Administrative Design Review

PROJECT #3033307-LU:
DELRIDGE WAY TOWNHOUSES
8417 DELRIDGE WAY SW
Seattle, WA 98106

Comment Summary_Markup Summary

PROPOSED OPTION—ADDITIONAL VIEWS

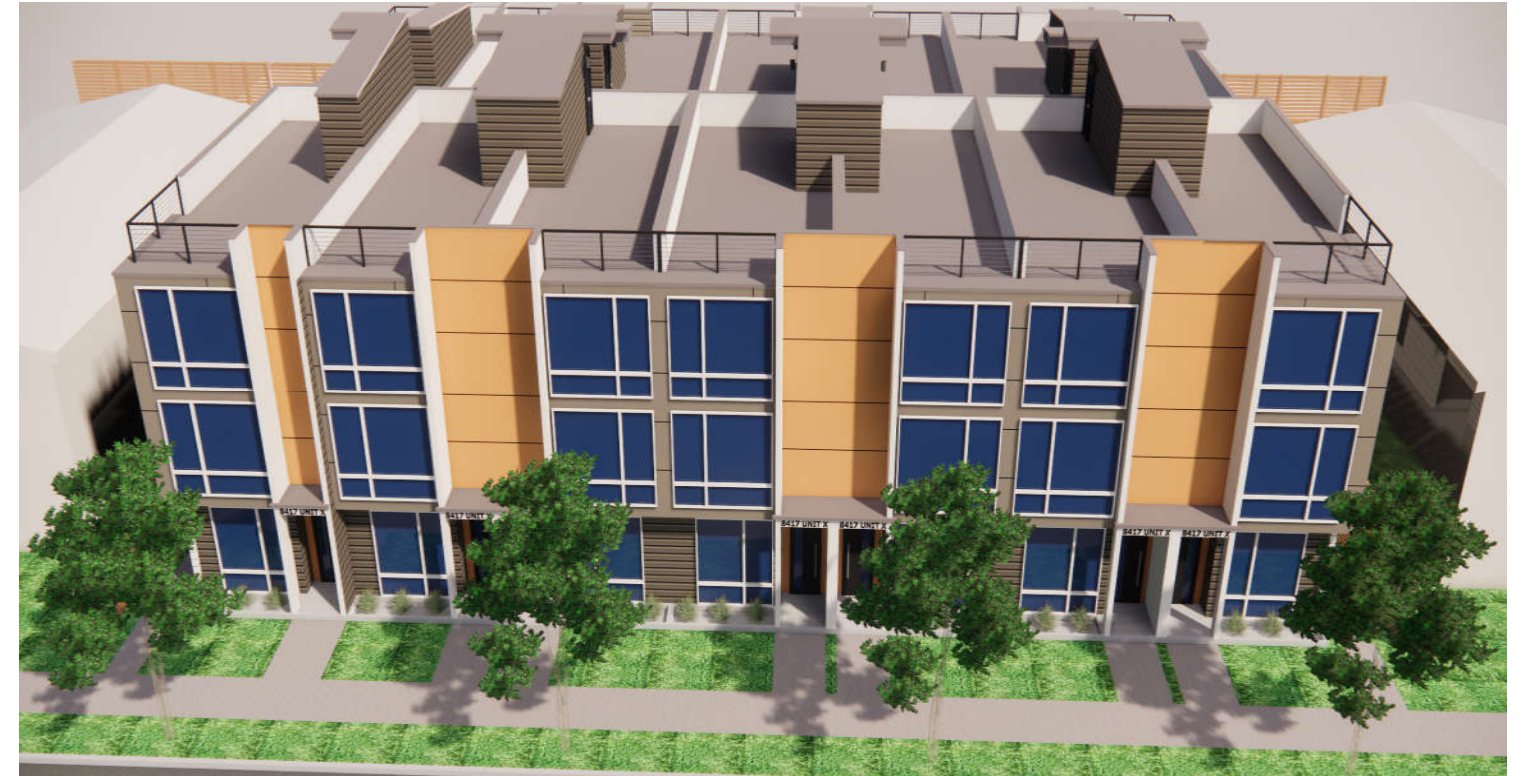
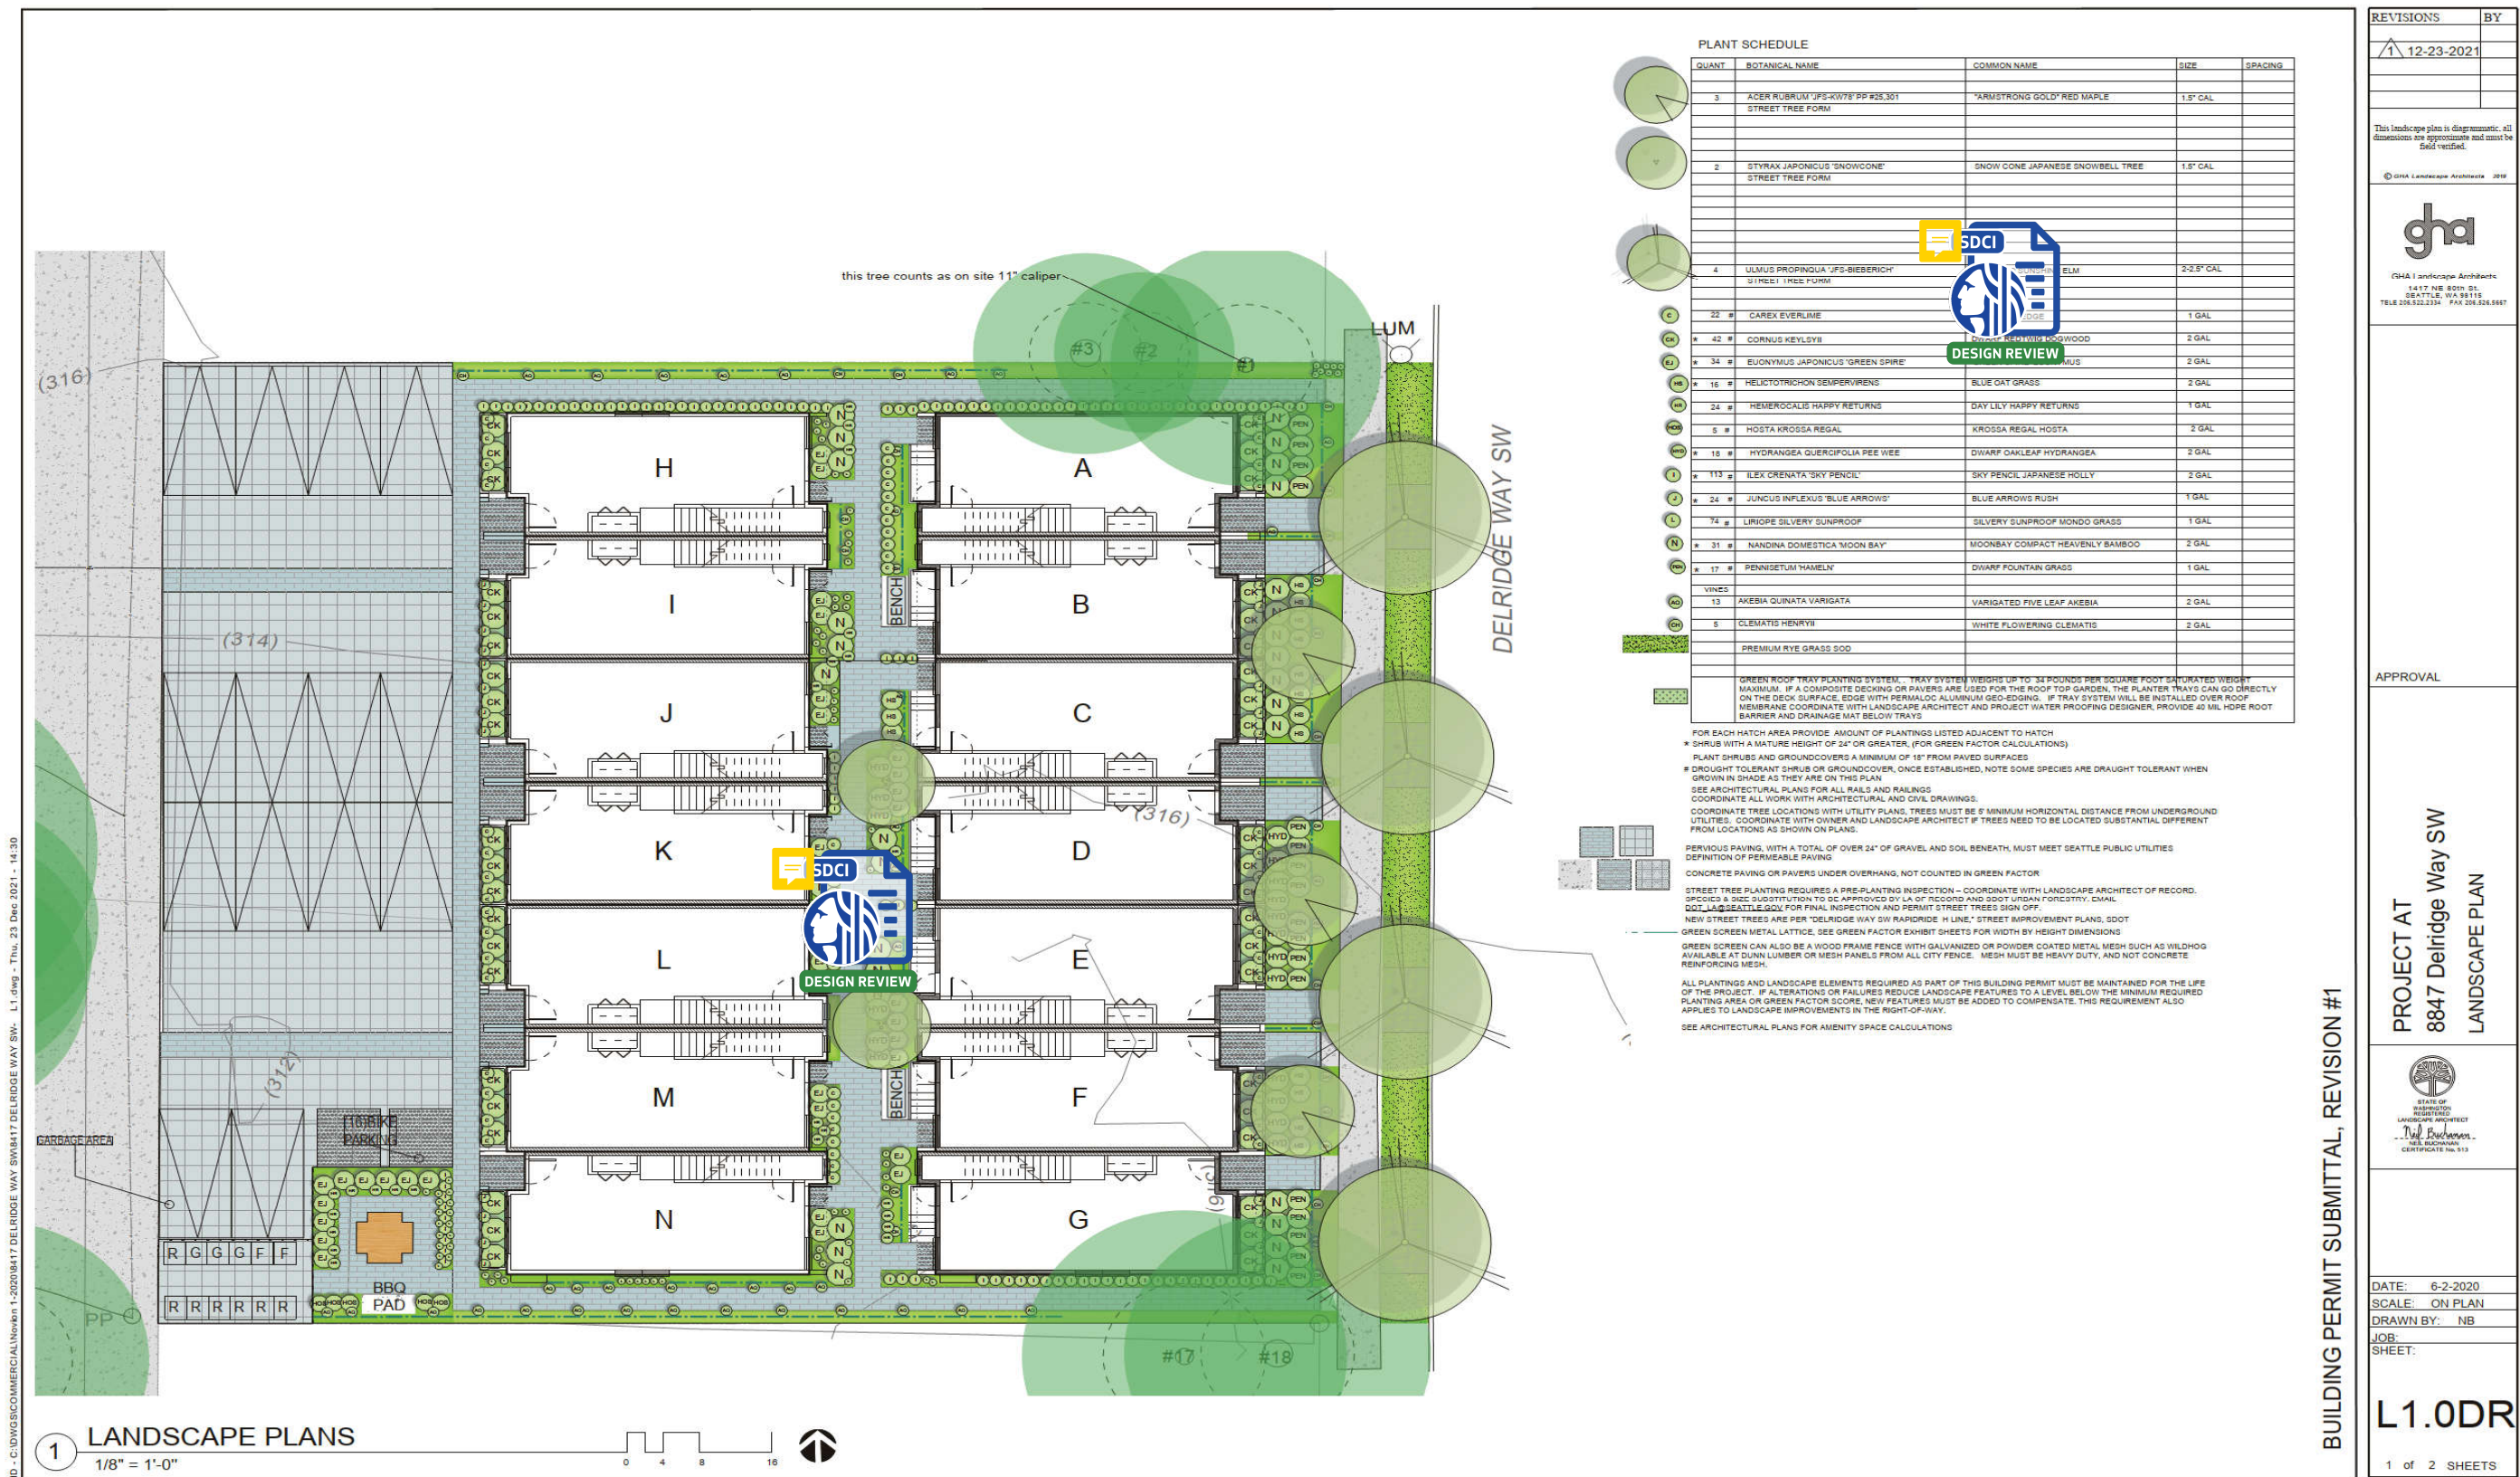
Provide additional perspectives looking from the other direction down Delridge Wat SW, the alley, and looking down the central circulation path. Accurately show the at-grade planting and bioretention planters in the views and on the elevations to show how high blank concrete walls are being addressed.

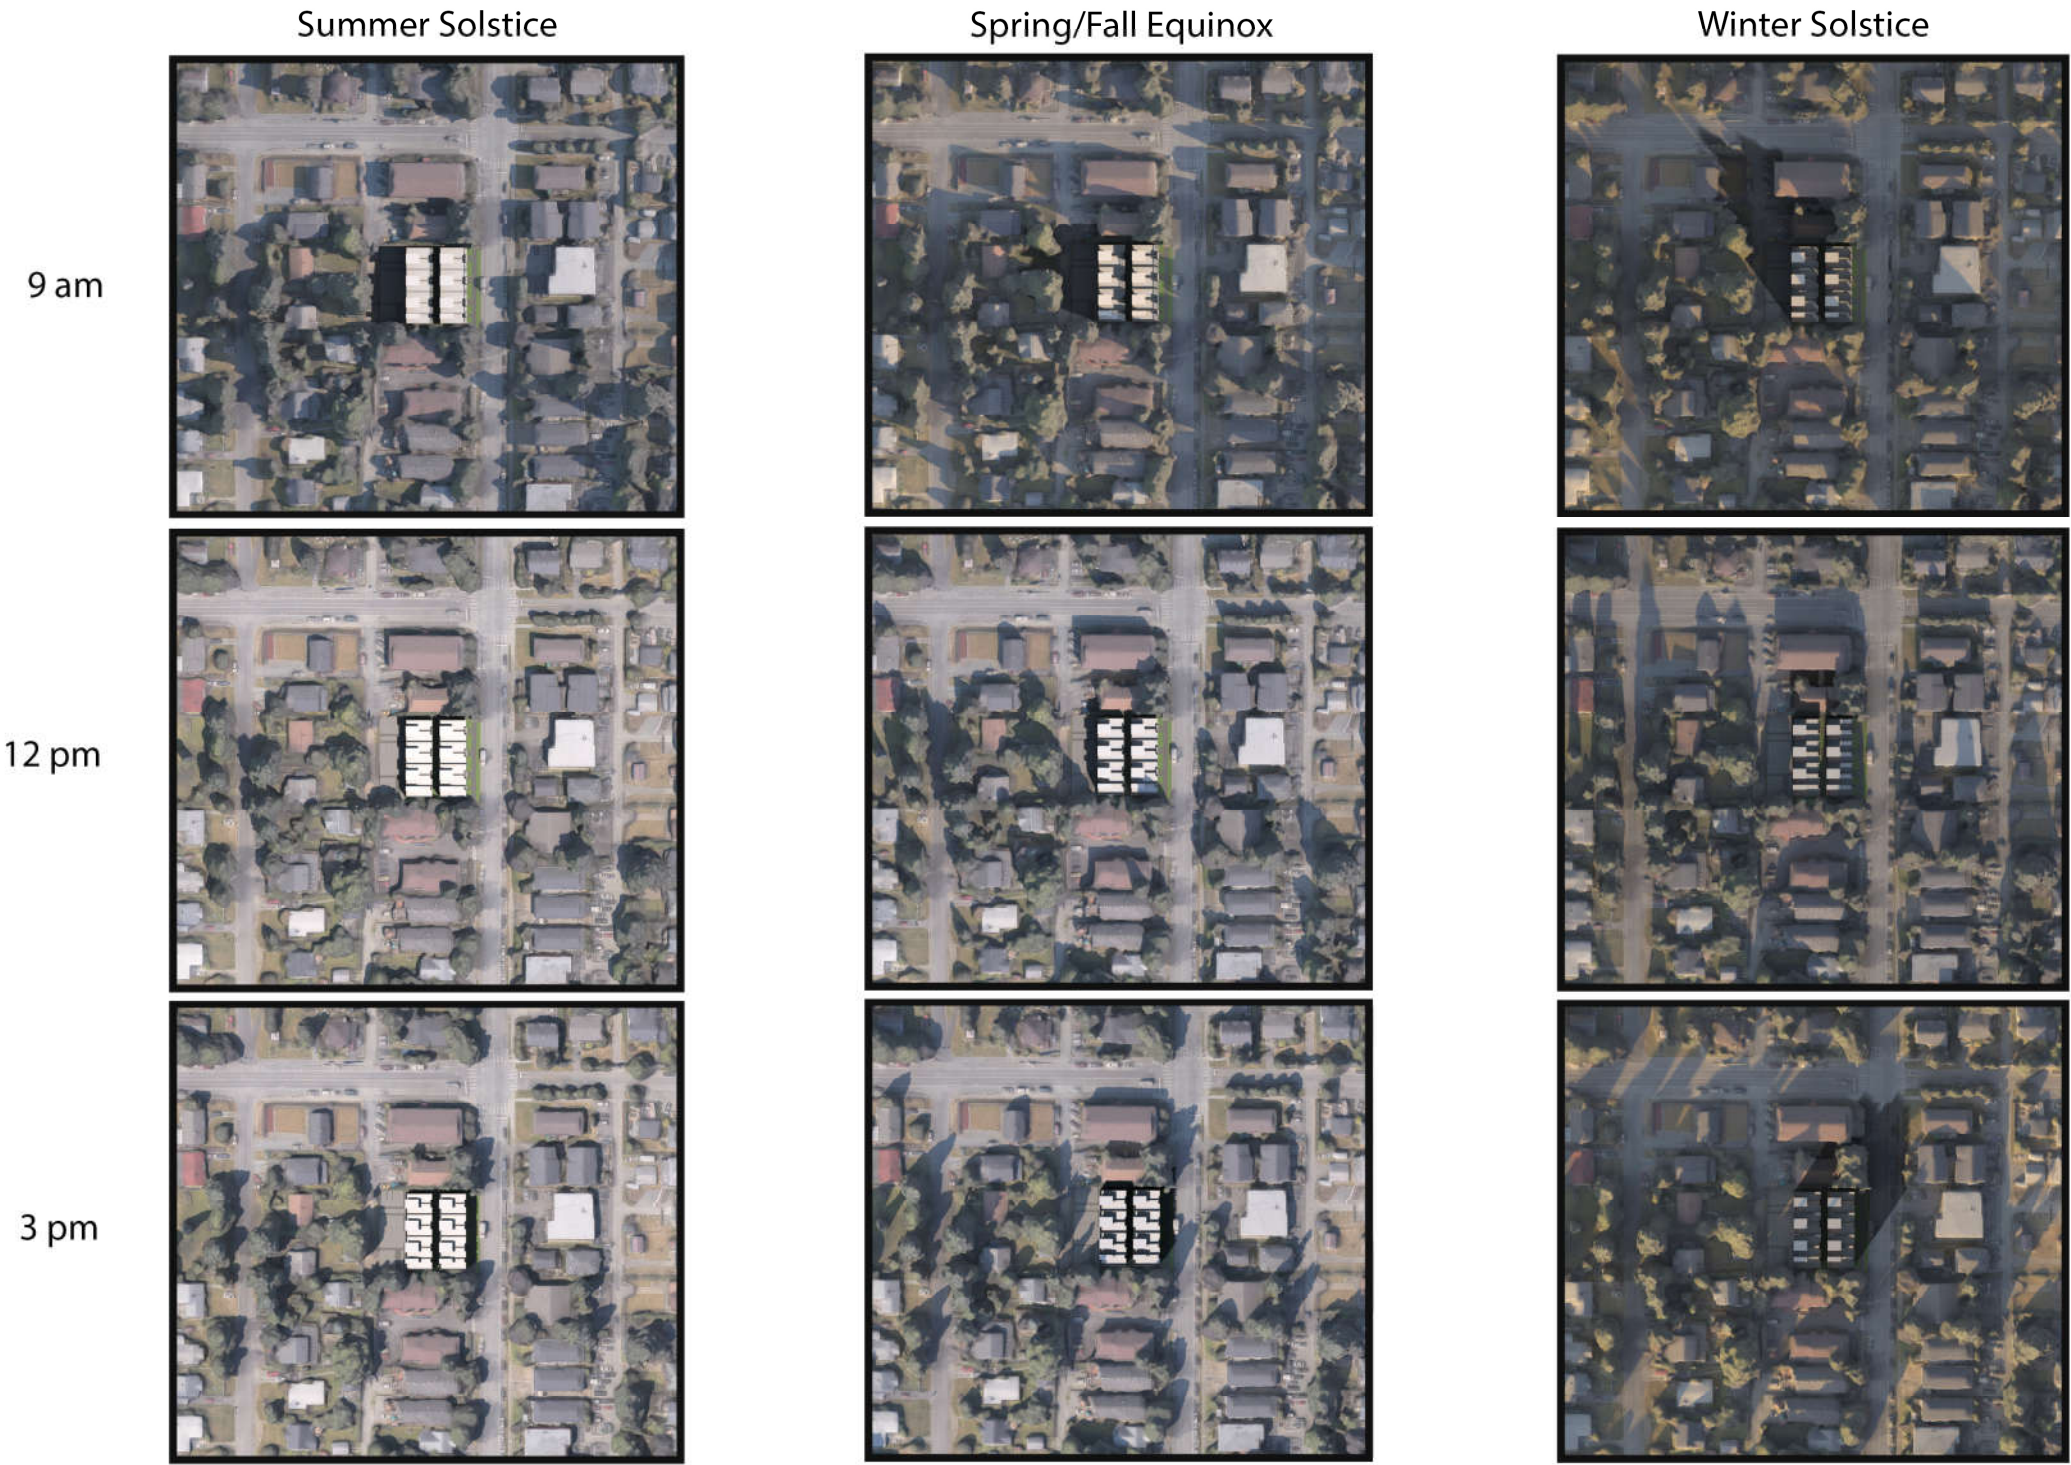
Provide height information in the legend.
